07/15/21
CAL FTL 91-002

Subject: Replacement of Sears Driver Seat Metal Mounting Clip to Eliminate Seat Sensor Chaffing Issue

Models Affected: Freightliner New Cascadia vehicles built from June 2018 through June 2021.

Fig. 1, Chaffed Driver Seat Sensor Harness

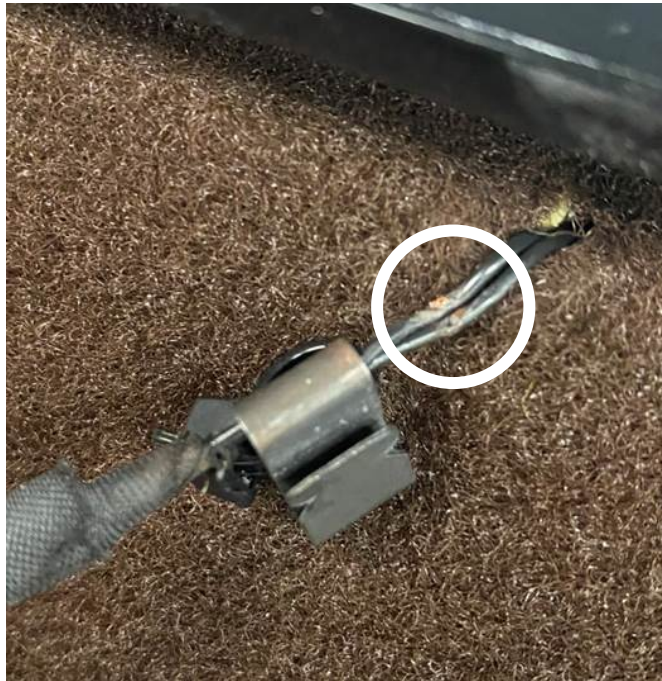
The seat sensor harness on New Cascadia vehicles ordered with a Sears driver seat (sales code 756-1H2) may experience chaffing due to the incorrect mounting of a metal clip edge; excessive chaffing may result in disabling adaptive cruise control. The metal clip edge needs to be replaced by a plastic clip edge to resolve this issue.
